PRODUCT CHANGE NOTIFICATION (PCN)

AMJG0808-0300-GYB-26
MODULAR CABLE

CHANGE NOTIFICATION: PCN 20220425_AMJG0808-0300-GYB-26

DESCRIPTION OF CHANGES:
CHANGE OF DATA SHEET
CHANGE OF DATA SHEET
New Draw.-No. ASS_7947_CArev02

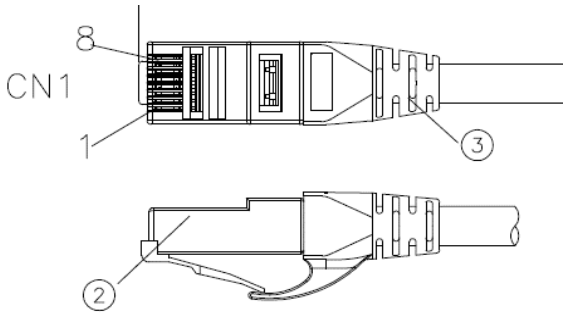
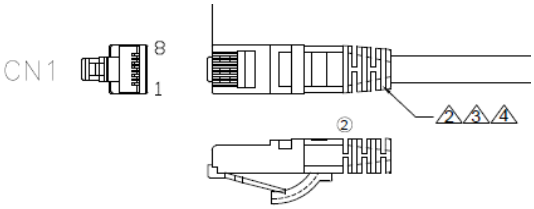
REASON FOR CHANGE:
CHANGE OF PRODUCT LOCATION
CHANGE OF PRODUCT LOCATION

③	Molding	PVC 45P Color: see order code	NA	KG
②	CONNECTOR	RJ45 8P8C two fork 3u" gold plated with metal shield	2	PCS
①	CABLE	CAT5e FTP (26AWG*1PR)*4+D+A+PVC OD=5.2±0.3MM Color: see order code	NA	MM
NO:	NAME	DESCRIPTION	Q'TY	UNIT

4	AL-Foil	Double-sided conductive aluminum foil ②	2	PCS
3	Molding	PVC 65P Color: see order code ②	NA	KG
2	CONNECTOR	RJ45 8P8C two fork 3u" gold plated with metal shield	2	PCS
1	CABLE	CAT5e F/UTP (26AWG*1PR)*4+D(AM)+A+PVC OD=5.2±0.3MM Color: see order code ②	NA	MM
NO:	NAME	DESCRIPTION	Q'TY	UNIT

Drawing-No.
ASS 7947 CA

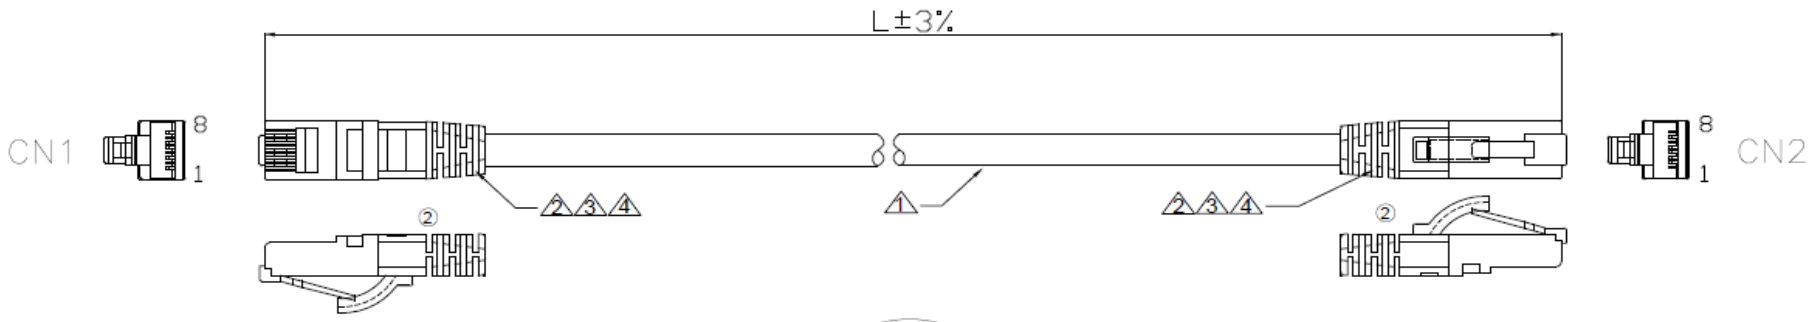
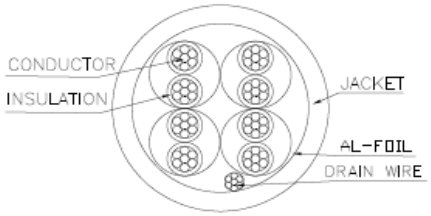
Id.	Modification	Date	Name
②	Change the plant	12.04.2022	Amy
①	Update the WSW order code	02.06.2017	Amy
⓪	Drawn	30.03.2017	Amy
